**Re: Ceja Vista Apartments PHASE 1/ 10001 Ceja Vista Rd. SW**  
**Request for Certificate of Occupancy**  
**Transportation Development Final Inspection**  
Architect's Stamp dated 11-25-2019 (P09-D002G)  
Certification dated 05-04-23

RE: Ceja Vista  
10001 Ceja Vista Road SW  
Zone: R2  
Submittal: TCL for Final C.O. of Phase 1

RE: Ceja Vista  
10001 Ceja Vista Road SW  
Zone: R2  
Submittal: TCL for Final C.O. of Phase 1

SITE PLAN  
FOR BUILDING  
PERMIT

SDP1.1

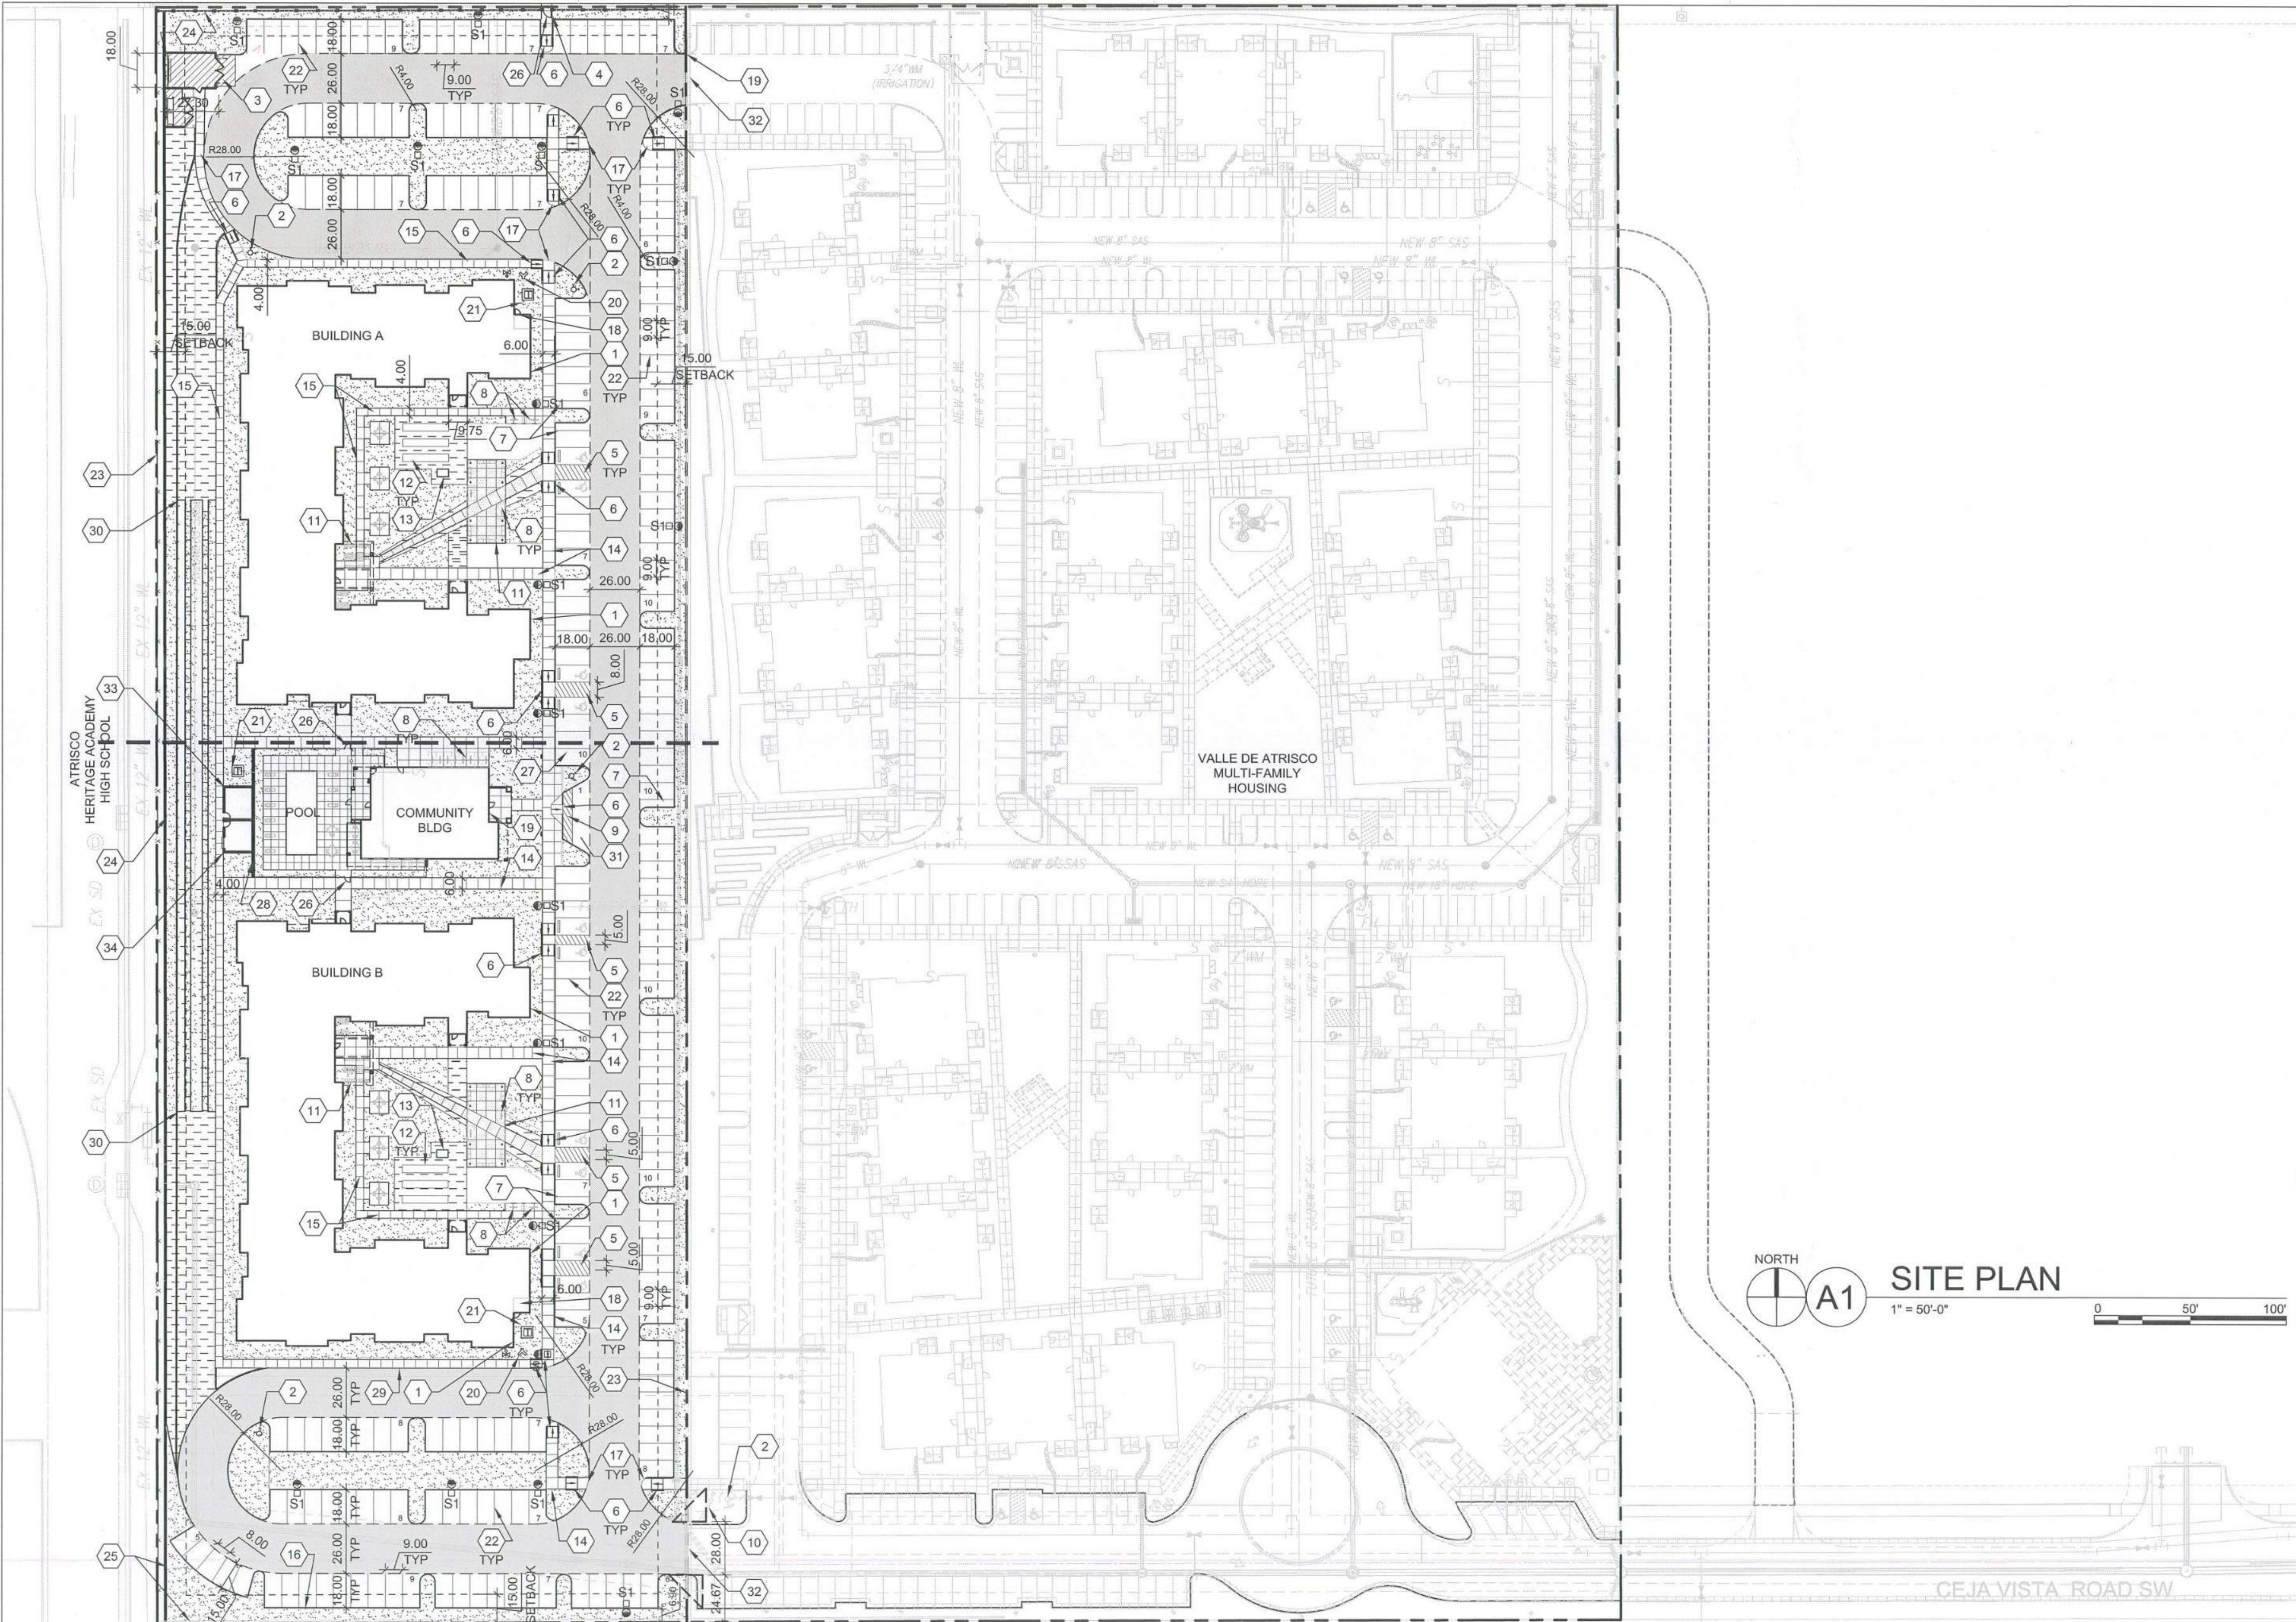
TRASH COMPACTOR  
ENCLOSURE WALLS ARE  
INCOMPLETE. BLOCK TO  
COMPLETE IS ON ORDER

GATES ARE ON ORDER

SIDEWALK IN FRONT OF  
TRASH ENCLOSURE  
HAS BEEN WIDENED TO  
5 FEET AS OF 5/22/23TRASH ENCLOSURE WAS  
REVISED TO ACCOMMODATE  
5 BINS FROM 2 BINS.OUTDOOR SHOWERS  
OMITTED BECAUSE  
POOL WAS OMITTED.FENCE BOUNDARY  
REVISED, NOT YET  
INSTALLEDPOOL OMITTED; ARTIFICIAL  
TRUF WITH SHADE COVER  
INSTALLED IN ITS PLACELIGHTING NOT YET  
INSTALLEDPHASE 1  
PHASE 2PEDESTRIAN GATE HAS  
BEEN INSTALLED, 5/23/23.  
FIRE ACCESS GATE WAS  
OMITTED.  
ENTRY GATE  
OMITTED.  
PEDESTRIAN GATE  
OMITTED  
RELOCATED ACCESSIBLE  
SITE ACCESSVAN ACCESS AISLES  
HAVE BEEN REVISED  
TO BE 8 FEET WIDE AS  
OF 5/22/23STRIPING WAS  
OMITTED WITH  
OMISSION OF SPEED  
TABLE RAMPVANPOOL PARKING  
SIGNAGE HAS BEEN  
INSTALLED AS OF  
5/23/23SPEED TABLE RAMP  
WAS OMITTED.  
SPEED BUMPS WILL  
BE INSTALLED AT A  
LATER DATE.STRIPING WAS  
OMITTED WITH  
OMISSION OF SPEED  
TABLE RAMP
